STAFF REPORT
CITY OF BEVERLY HILLS

**For the Design Review Commission
Meeting of August 5, 2010**

SUBJECT: A request for an R-1 Design Review Permit to allow a new two-story single-family residence located in the Central Area of the City, north of Santa Monica Boulevard at 631 North Crescent Drive. (PL 1017464)

Proposed North Elevation
(Elevado Ave)

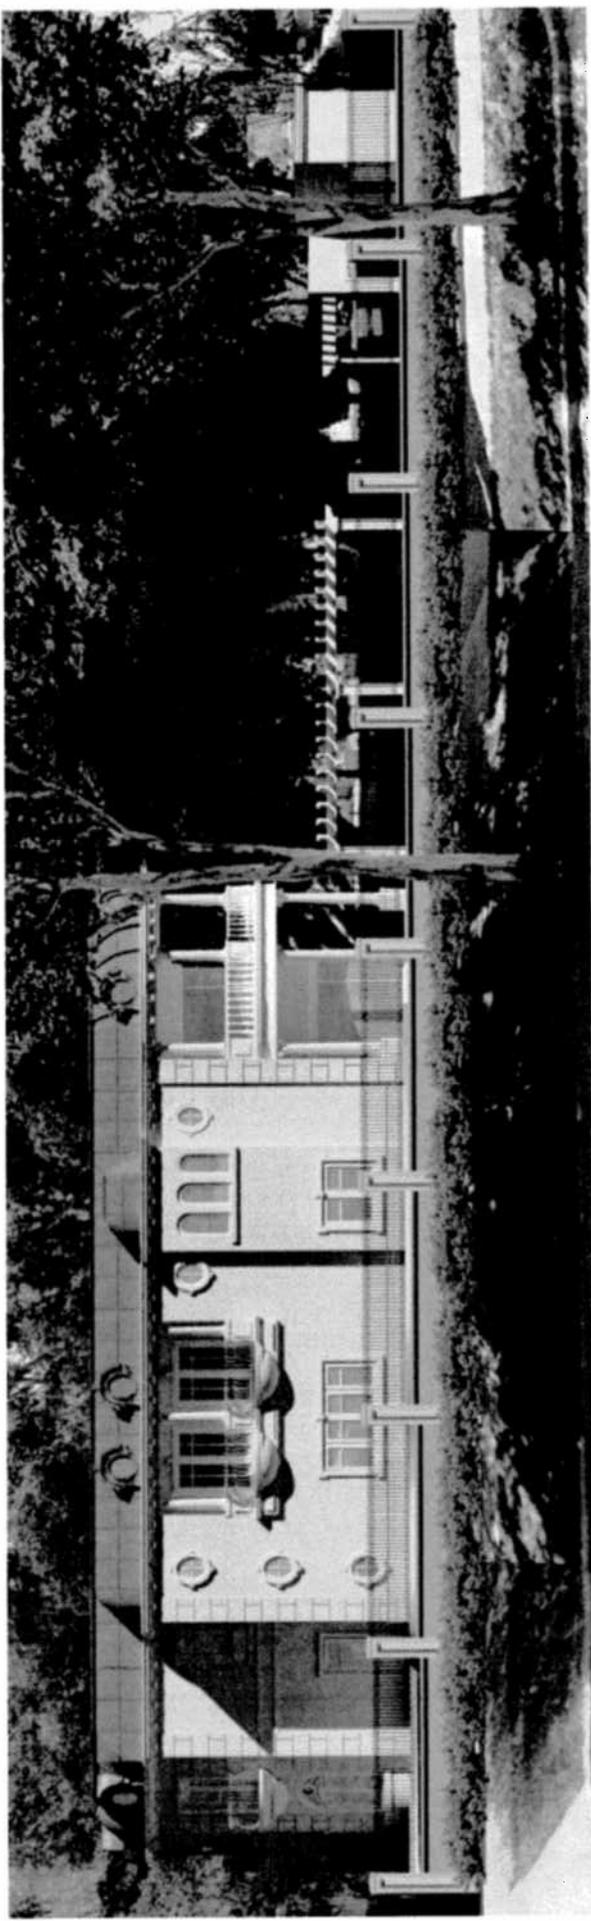
The proposed residence is setback more than the required setback distance from both Elevado Avenue (proposed 21'-6" vs. required 15') and Crescent Drive (proposed 53' vs. required 40'). These larger setbacks soften the impact of the large residence on the neighborhood. In addition to the setbacks, the residence has been designed with an angled corner facing the intersection of Elevado Avenue and Crescent Drive which will lessen the impact of the project on the streetscape. Vehicular access to the site and the subterranean parking have been carefully considered and designed, and will alleviate the need for a bulky gate to access the property from the rear alley. The proposed front yard fencing is to be 6-feet in height, and has been designed with the top 3feet of the fence to contain wrought iron. This fence design extends along the street side (Elevado Avenue) property line and the front property line (Crescent Drive). The angled corner of the residence, the articulated façade and recessed windows with detailed balconies, the open fence design, and the generous setbacks (above minimum requirements) are welcome examples of qualities the Commission has been seeking to soften impacts of large homes on corner lots.
